SERVICETEKNOTES

TABLE OF CONTENTS

4115B FET KIT (050-1829-00) ADD DIODES FOR ARC PROTECTION

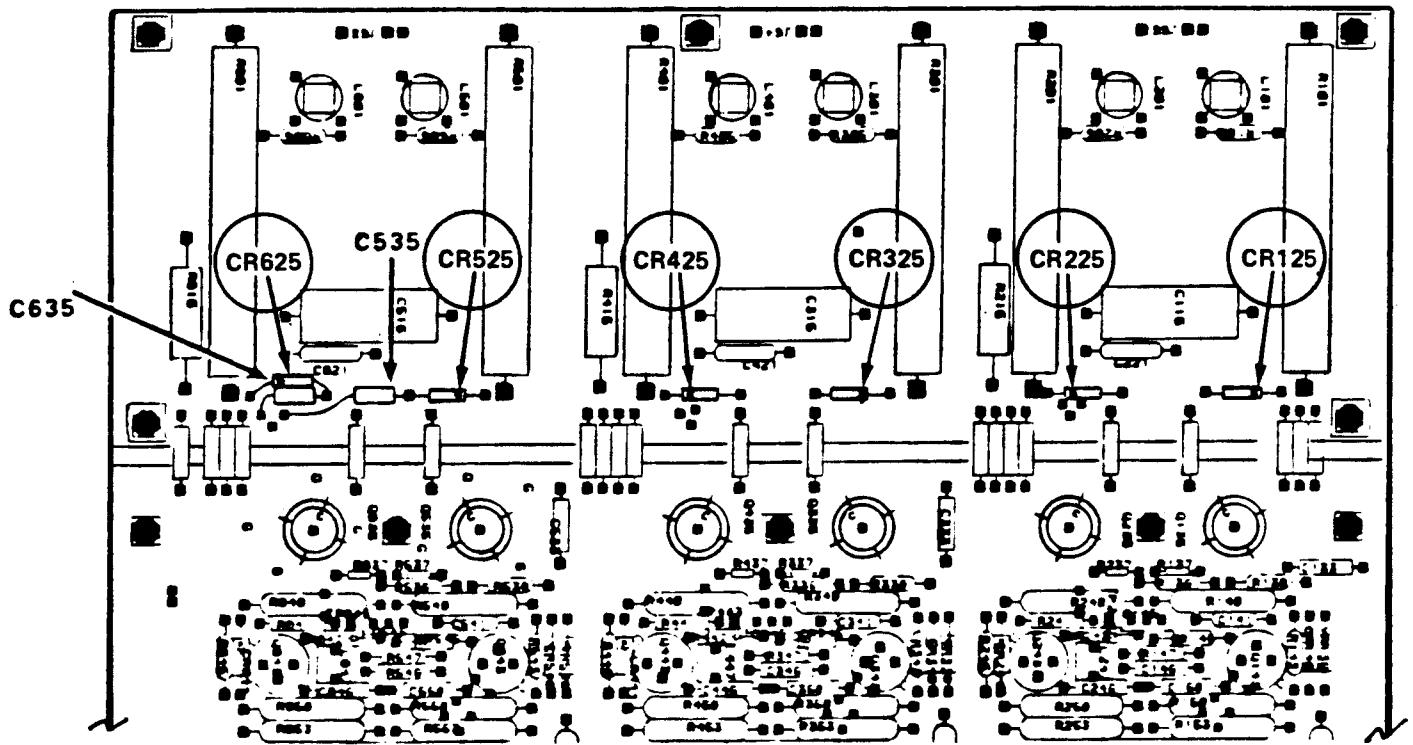
The new bipolar transistors on the Video Amplifier, for the 4115B, will fail on occasion with CRT arcing. Six diodes P/N 152-0333-00 have been added to the video output circuitry to provide protection from CRT arcing.

The cathode end of the diode is connected to a by-passed 62V supply and the anode end connects to the collectors of each of the video output bipolar transistors. See figure for placement; note, cathode band for polarity.

The Video Amplifier board rolls to 670-7651-02. The FET replacement kit 050-1829-01 will contain the six new diodes.

Figure 1.

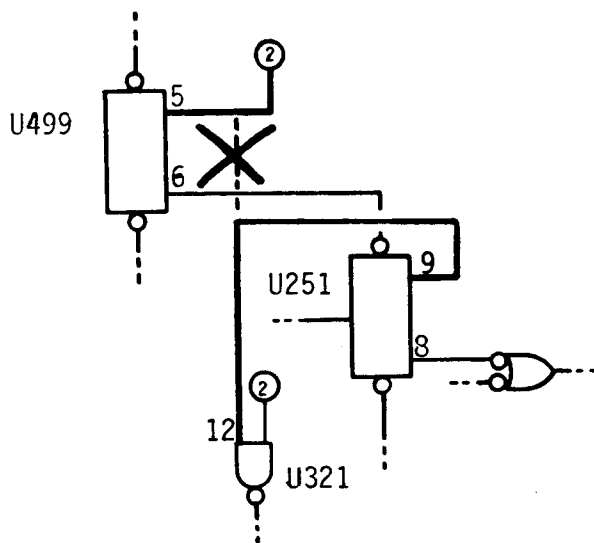
The trace from pin 5 of U499 to pin 12 of U491 is in error. A correct schematic showing pin 9 of U251 to pin 12 of U491 is given below.

Corrected Schematic for CM670-6391-53
Logic Board

Figure 1.

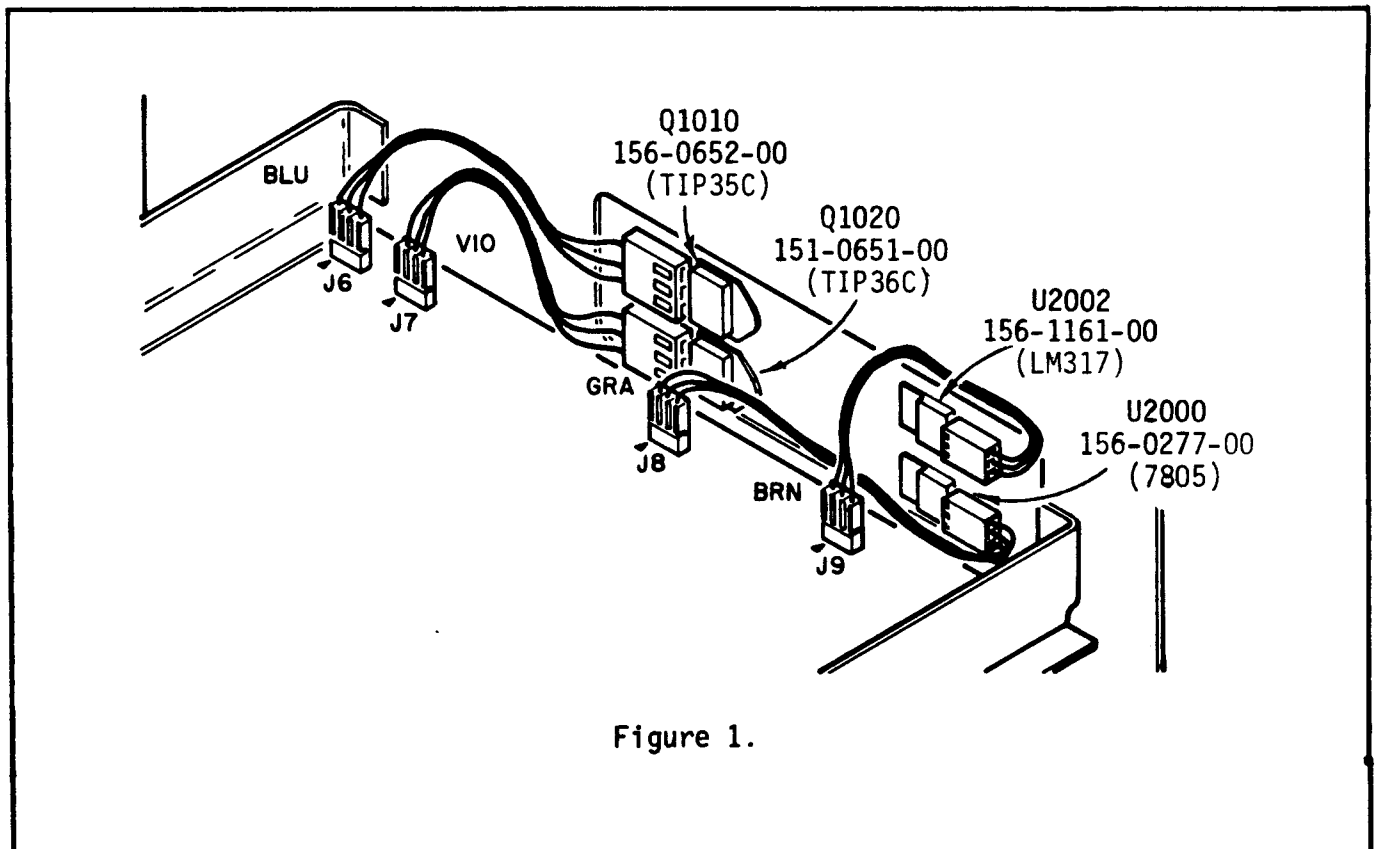
Mainboard replacement in the 4635 requires removal of the mainboard from the backpanel and heatsink. Once the wire assemblies connecting Q1010, Q1020, U2000 and U2002 are removed from J6, J7, J8 and J9, it is easy to mistakenly swap leads and create a failure. To reduce this occurrence, the proper configuration of the heatsink power devices and their connecting cables is illustrated below. This illustration also applies to 4633A modified products such as the 4633AJE, 4633AJR, 4633A Mod JL/JN and 4633A Mod VA/VB/VC.

Figure 1.

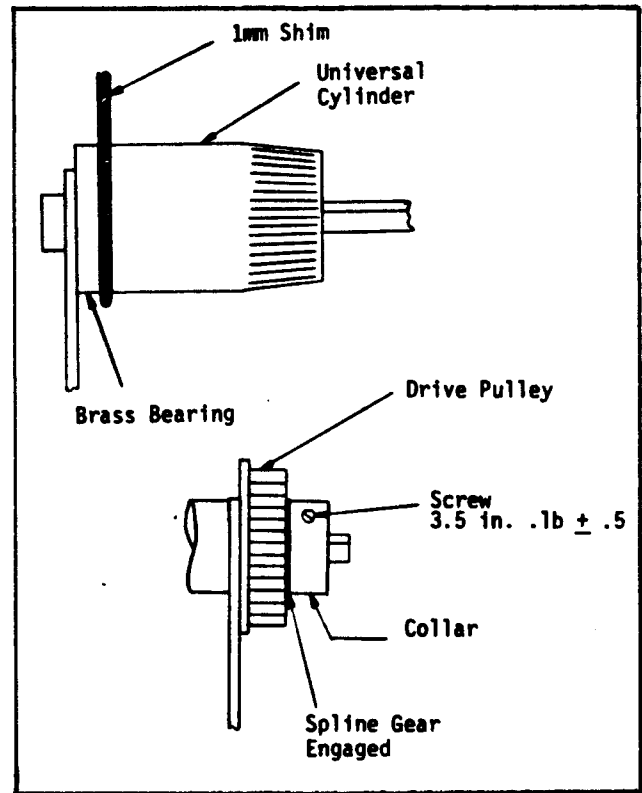
- A. Loosen the screw on the collar so that the Spline Gear moves freely on the shaft (Figure 1).
- B. Insert a 1mm (.039") shim (feeler gauge) between the universal cylinder and the brass bearing located on the left side assembly (Figure 1).
- C. While pushing the right end of the tractor drive shaft to the left (with even pressure), slide the Spline Gear into the drive pulley and tighten the screw in the collar (3.5" lbs). (Figures 1 and 2)
- D. Remove the shim (Figure 1).
- E. Press down on the universal cylinder until it contacts the universal hub and hold it in that position (Figure 3).
- F. The distance between the drive pulley face and the Spline Gear face should be a minimum of 2mm (.078") (Figure 3). If the gap is less than 2mm, repeat the procedure.

Figure 1.

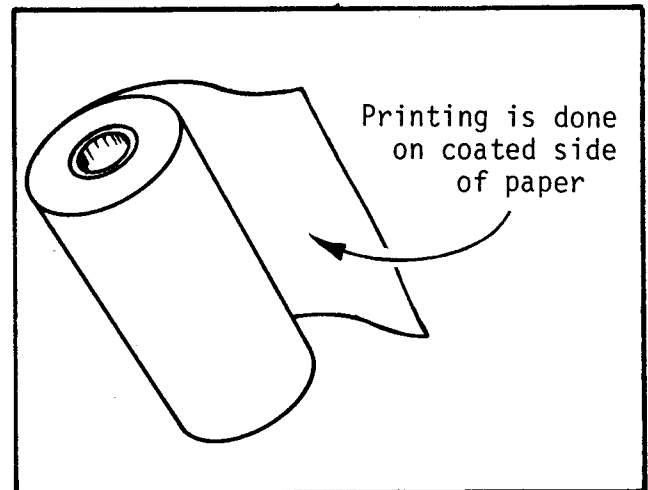
moistened and has a matte finish (no luster). The uncoated side is smooth and has a low lustre. Before concluding that a given roll of paper is bad, check that the paper is loaded correctly. Figure 3-4 in the operator's manual illustrates the loading of paper. If this is not the problem, check that the roll is wound correctly. The coated side of the paper should be on the inside of the roll (see figure 1 below). As a check, tear off a portion of paper and run it through the copier "inside out."
